# KAMI IRON ORE PROJECT

**Kami Iron Ore Project  
Amendment to the  
Environmental Impact Statement**

**VOLUME 3  
INFORMATION REQUEST RESPONSES**

February 2013

Figure 1.3.3 Final Discharge Points and Sediment Ponds

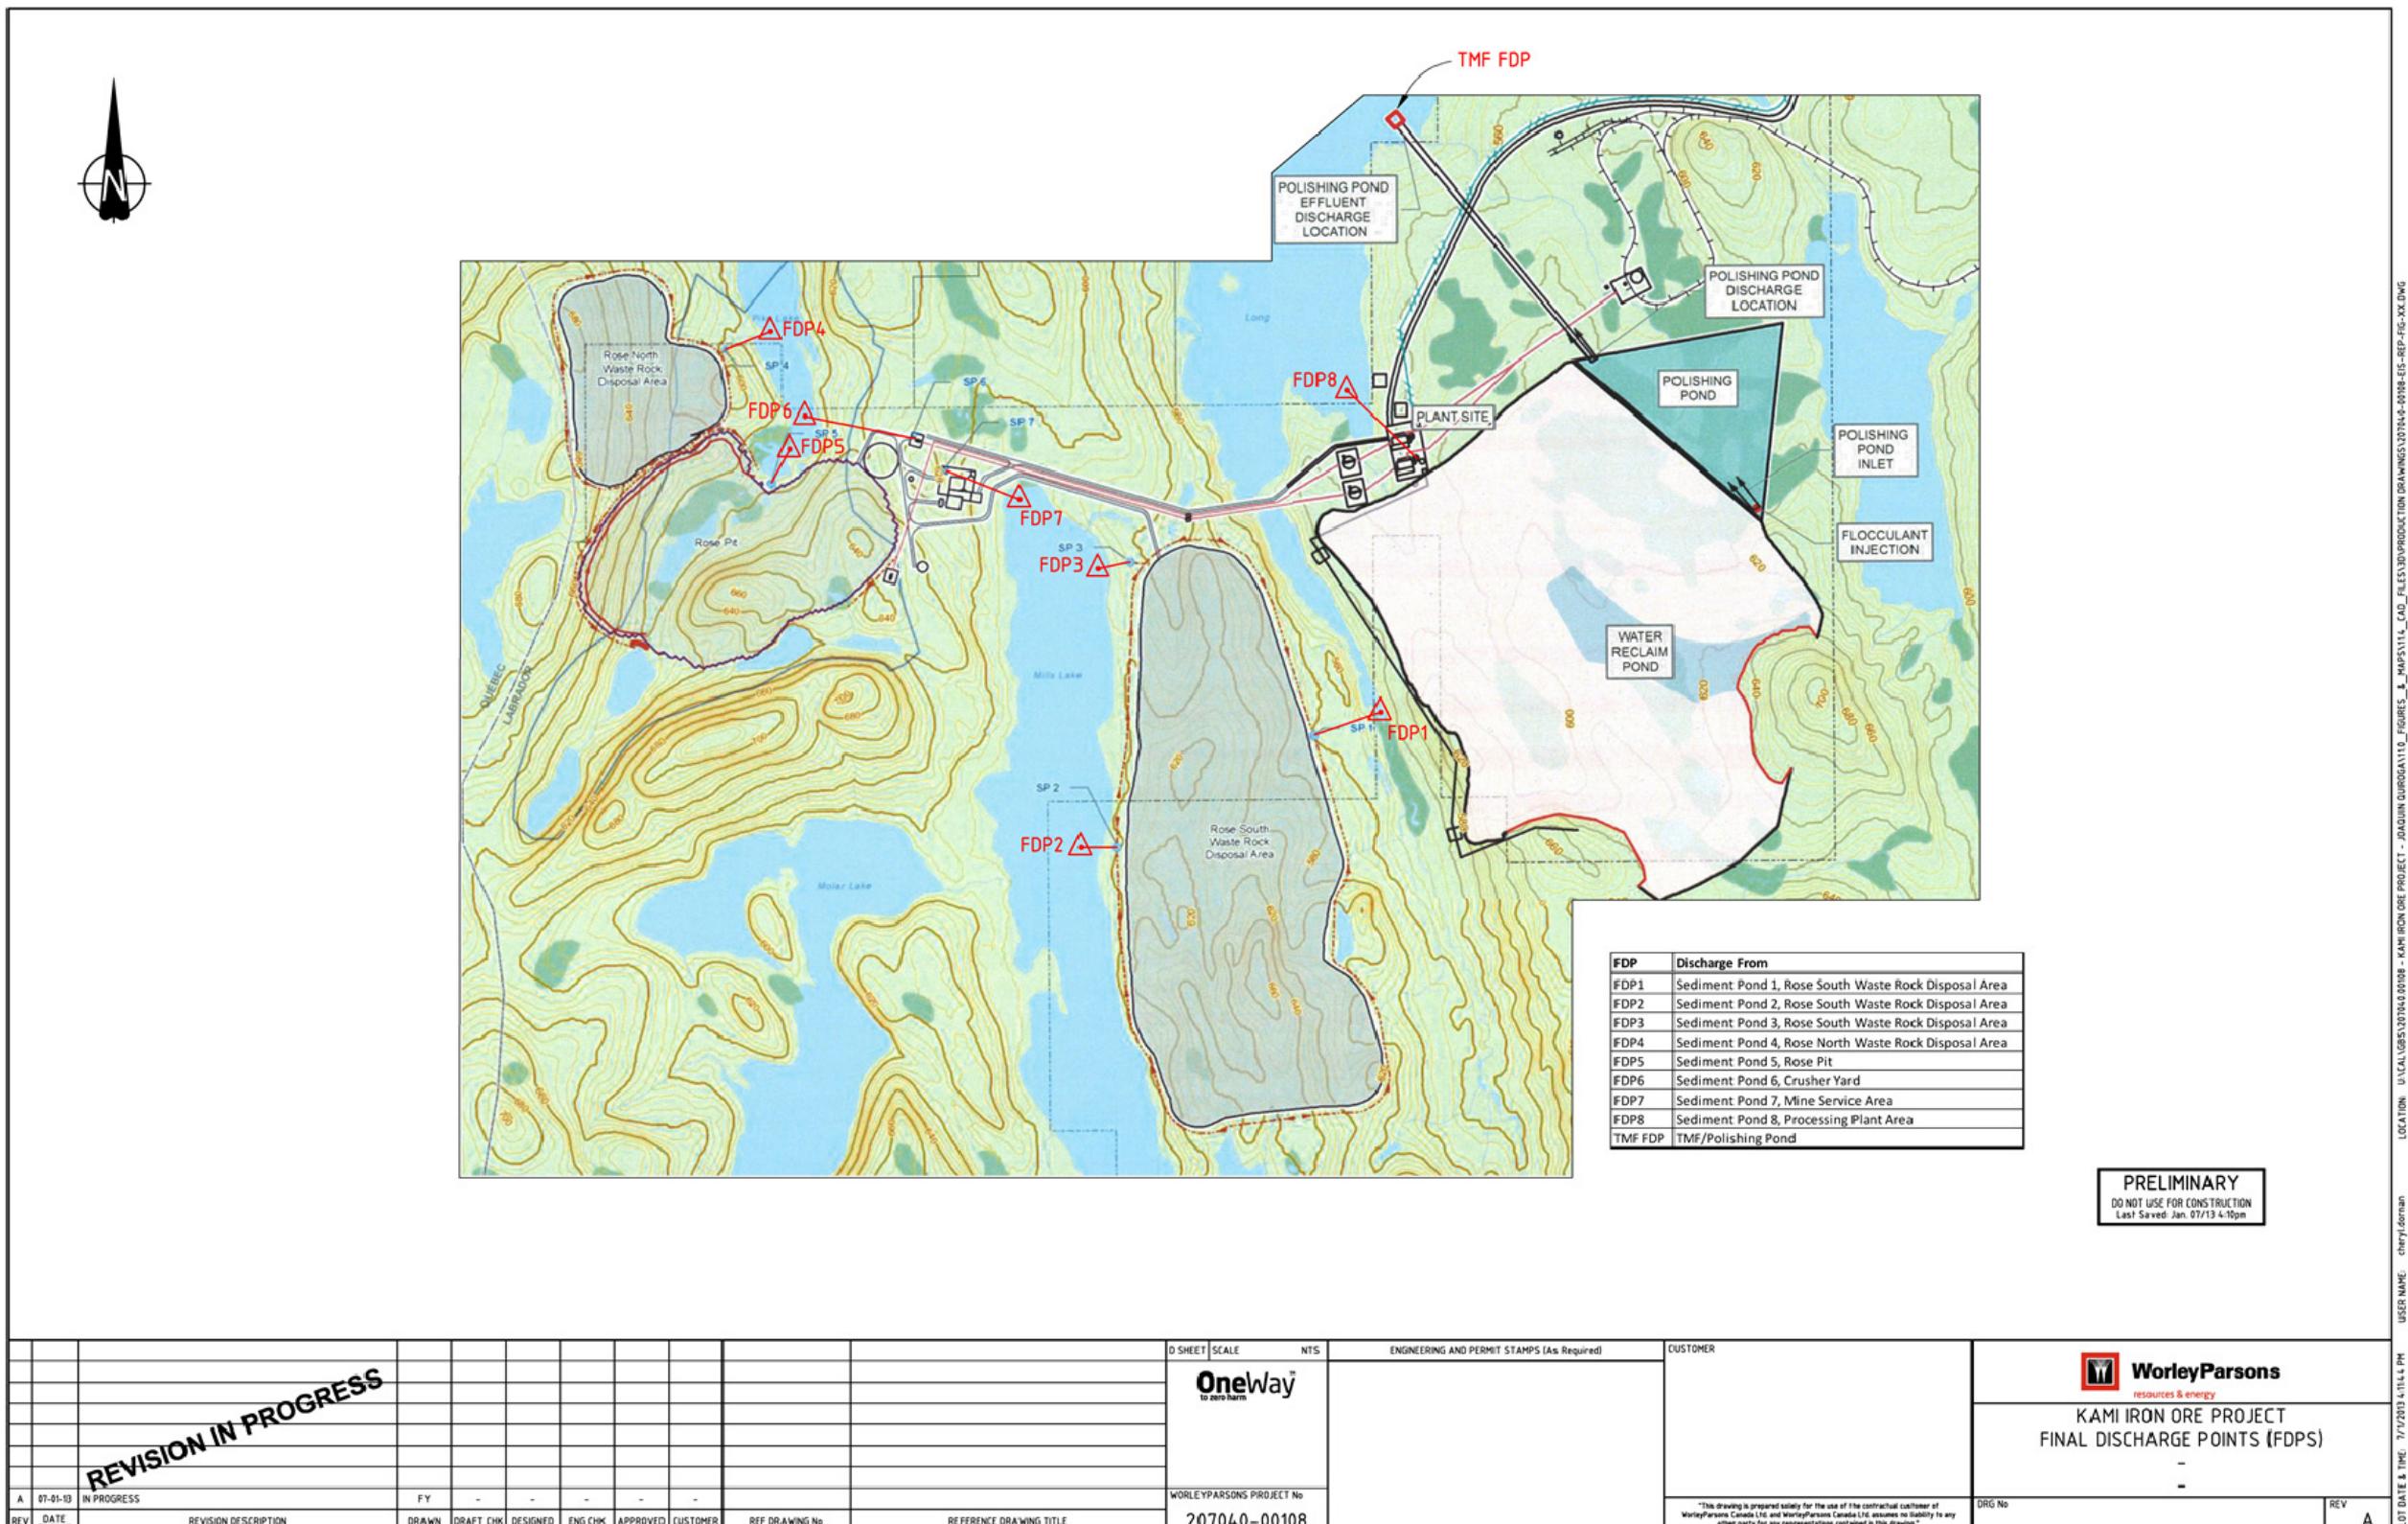
An example raised in this comment is that of the generation of sediment within the drainage collected in the open pit. Drainage will be collected in a sump or sumps at the bottom of the pit and then pumped to the crest of the pit where it will be enter a sedimentation pond as shown on Figure 1.3.3 below. The sump will be designed and constructed to minimize sediment pick-up in the pit. The sedimentation pond will be designed to handle the appropriate groundwater and surface water flows, as further described below, and provide for sufficient settling of sediment to ensure the discharge from the pond meets with the MMER criteria. Some general sedimentation pond design criteria is outlined in Table 1.3.3.

**Figure 1.3.6 Annual Precipitation Wetter / Dryer than the Average Year  
 (Updated EIS Figure 16.6, EIS Volume 1)**

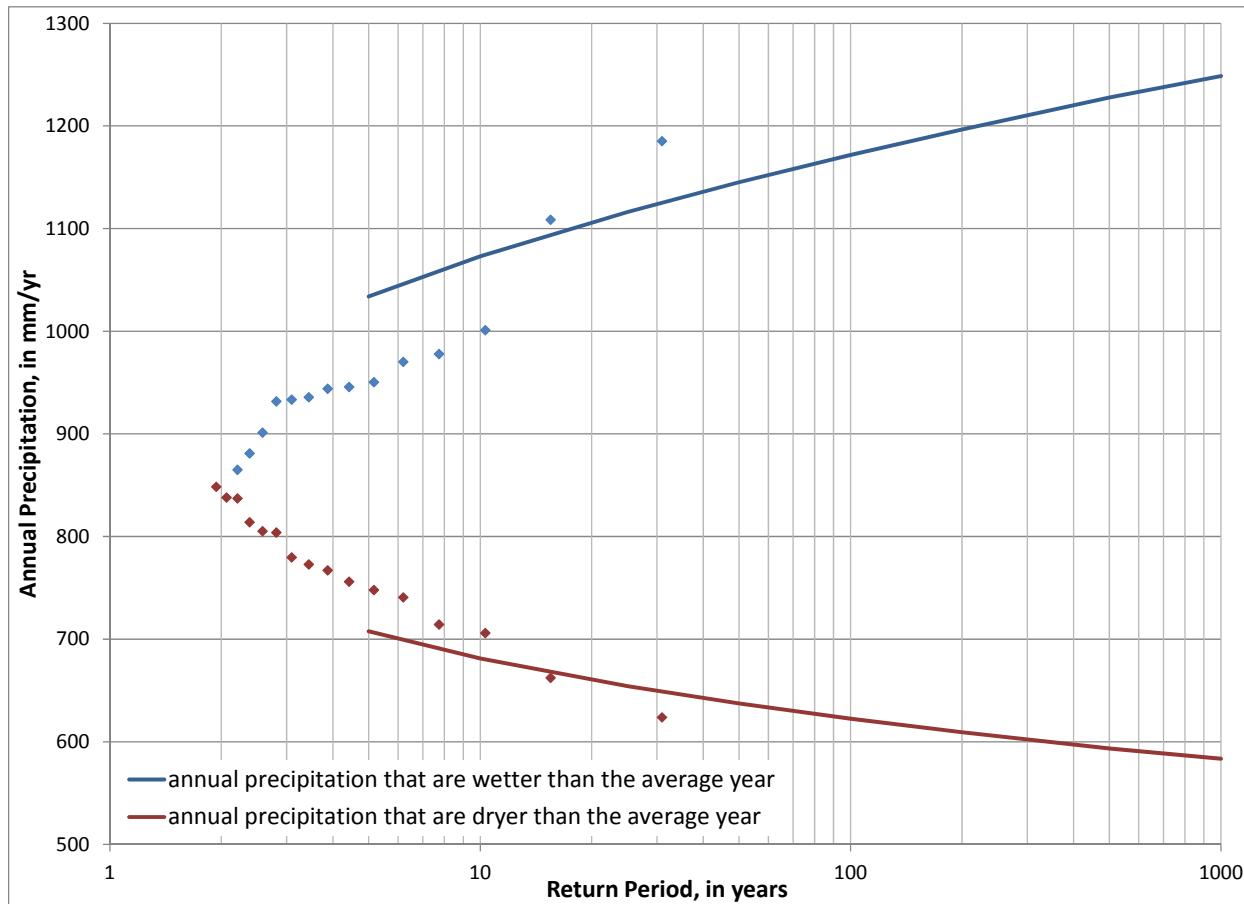
- There are inaccuracies associated with the Annual Precipitation Analysis shown in Figure 16.6, p. 16-37. The mean is plotted as having a return period of about 1 year which is inaccurate and the extrapolated curves don't match the data points. This should be re-visited as other important analyses are dependent on these data.

Figure 16.6 of Volume 1 of the EIS is revised to show the recurrence interval of the mean annual precipitation. A Log Normal statistical analysis was applied to the wetter and drier year precipitation dataset from the Wabush Airport weather station with the curves representing best-fit from the Log-Normal analysis.

**Figure 1.3.7 Rose Pit Water Management Plan (Revised Figure 16.42 of EIS Volume 1, Part II)**

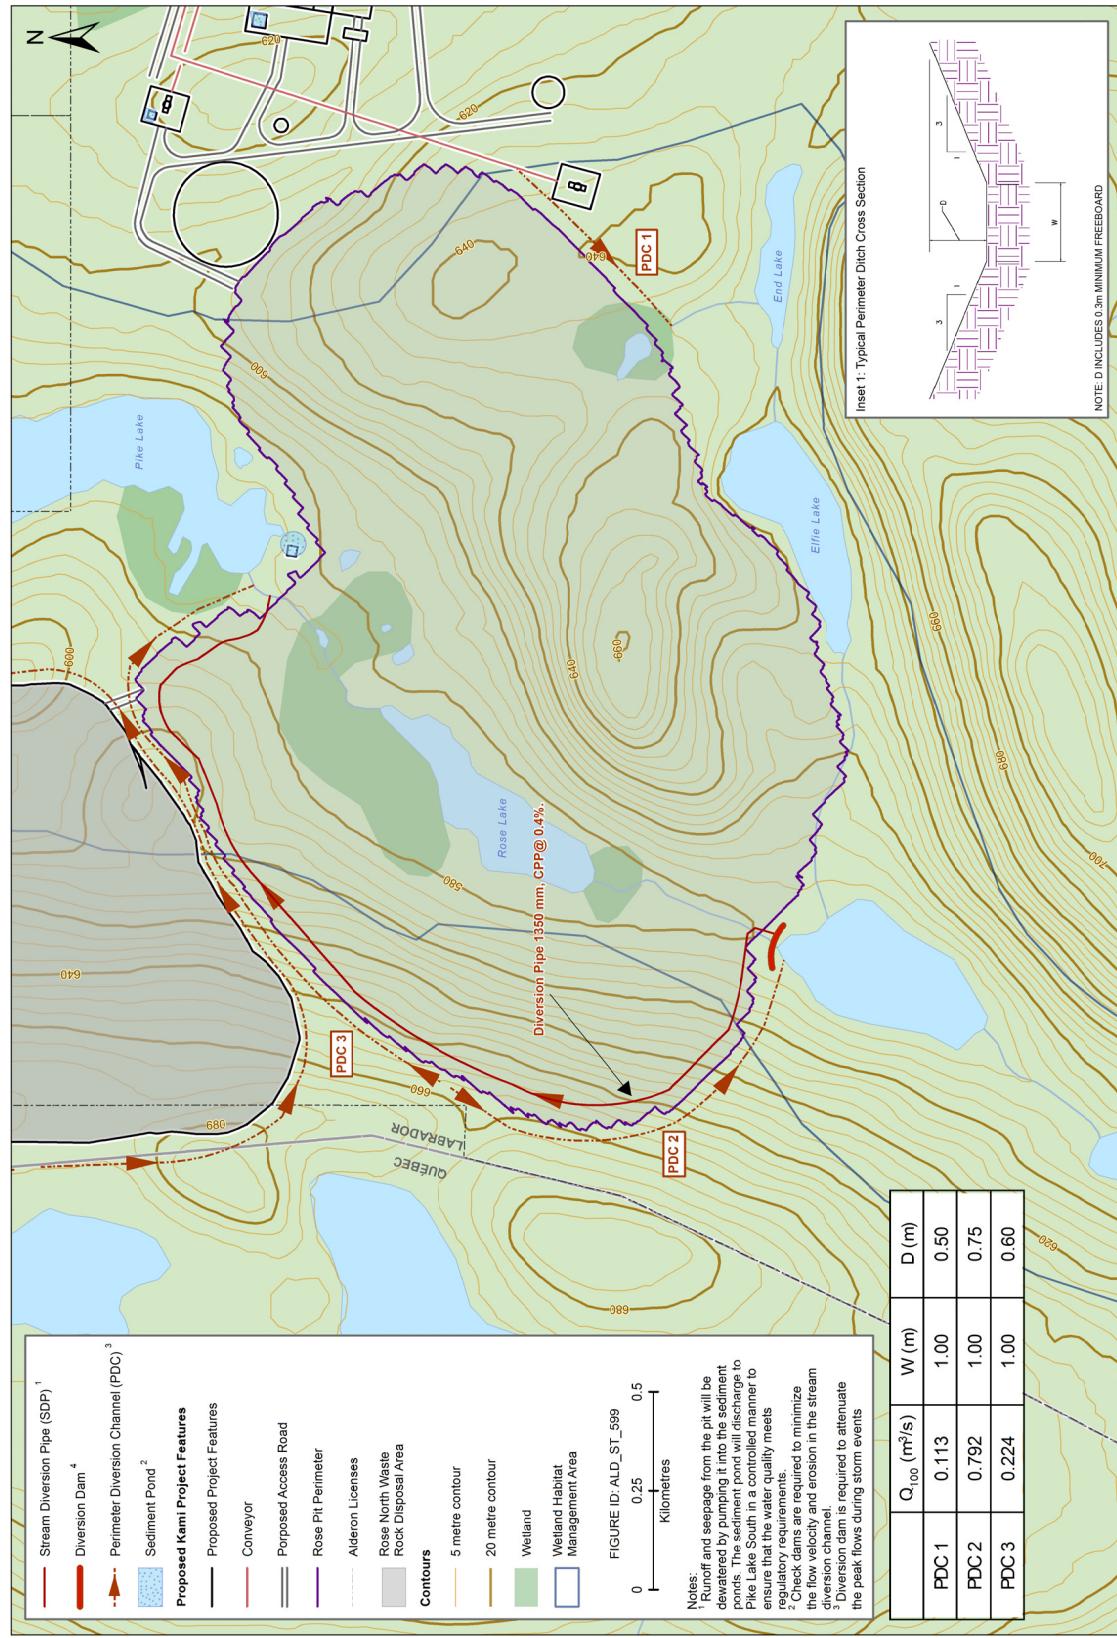
In Figure 16.43, the diversion pipe that is proposed to maintain flow from SP-01 and SP-02 downstream to Pike Lake is positioned behind the dam. If the position of the dam in this figure is correct, then it appears that the flow to Pike Lake from the headwaters upstream will not be maintained. The position of the dam and diversion pipe needs to be clarified in the figure and described in the text.

In addition, the purpose of PDC 1 in Figure 16.42 is not clear. It appears to drain into a small stream that runs into End Lake which is not mentioned in the text. The purpose of PDC 1 needs to be identified and described in order to determine the potential impacts to fish and fish habitat.

The location of the perimeter diversion channel (diversion pipe) on Figure 16.42 of Volume 1 of the EIS is incorrectly located and has been adjusted; it should be connected to the Diversion Dam as per the updated figure below (Figure 1.3.7). The intent is that base flow from the dam will be conveyed through a pipe in the dam foundation and will be aligned along the top of the Rose Pit cut. The intention of the dam is to prevent extreme flows from entering the pit and attenuate them to a peak flow that can be handled effectively and conveyed around the pit.

The purpose of PDC 1 in Figure 16.42 is to intercept and maintain the existing flow in the natural channel and divert it into End Lake, where it will be conveyed through the lake system and eventually to Pike Lake. The location and alignment of the diversion will be refined during detailed design as it may also be appropriate to divert this flow around the east side of the pit and back into the downstream portion of the same channel.
